SUBJECT: Bridge No. 3, W.P. 37-65, Site No. 37-231,
Highway 27 Underpass at Bloor St.,
District No. 6.

Hwy. 27 Underpass at Bloor St.,
 W.P. 37-65 -- Site No. 37-231,
 Dundas Interchange, Dist. 6 (Toronto).

We have reviewed Preliminary Plan D-6198-P1 for the above mentioned structure. Our comments are as follows:

D-6198-P1

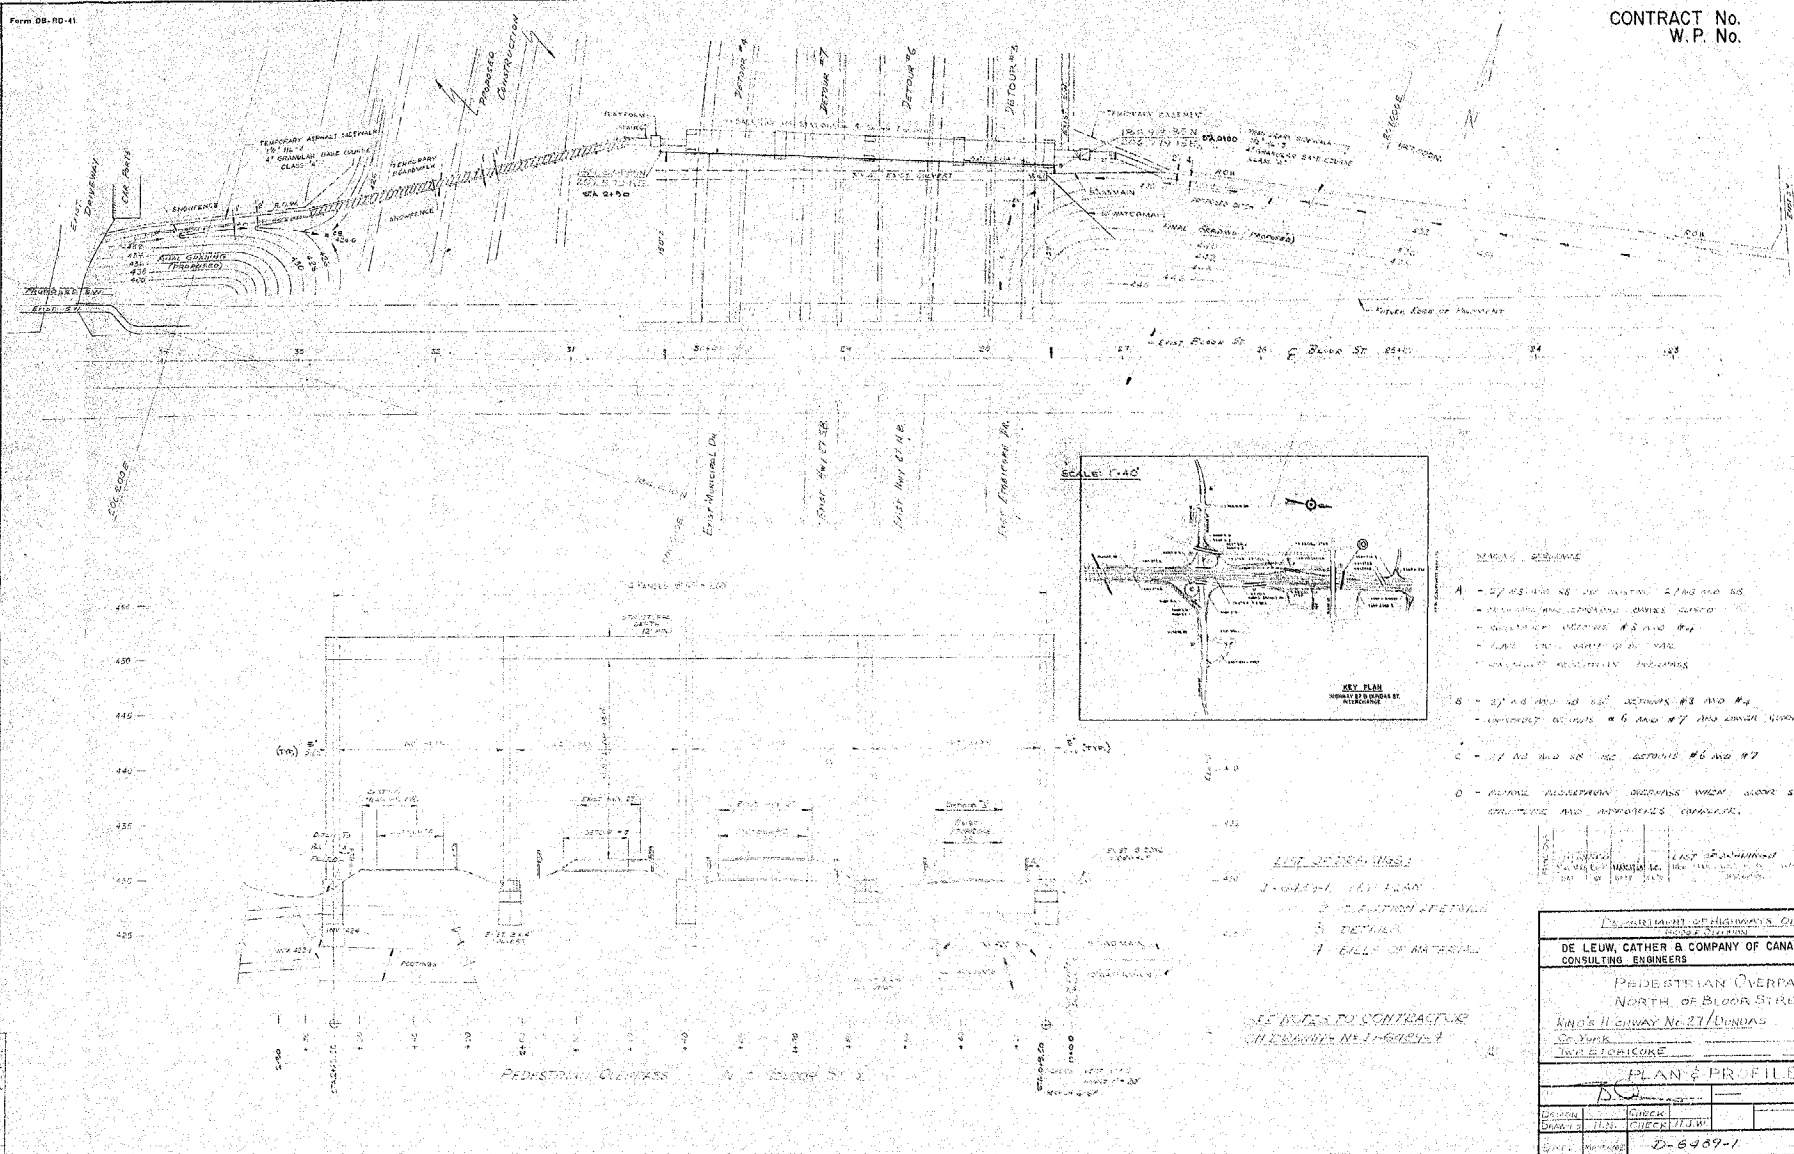
(1) No elevations of footings are shown on the plan; nevertheless, we have scaled these from the existing ground line, and it appears to us that the pier footings are as recommended in our report.

(2) The drawing shows the abutments to be supported on spread footings. Please note that our foundation report recommends piled foundations for the abutments.

No comments concerning spread footings beneath the piers. It is suggested, however, that - in view of recent experiences at the site of Hwy. #401 & #27 - pile lengths be provided for the abutments according to the Table below:

Location	No.	Piles Supplied	Type	Design Load
East Abutment	20	33 Ft.	12 BP @ 53	70 T/Pile
West Abutment	20	22 Ft.

The above pile lengths include a one-ft. allowance for cutting off buckled ends.
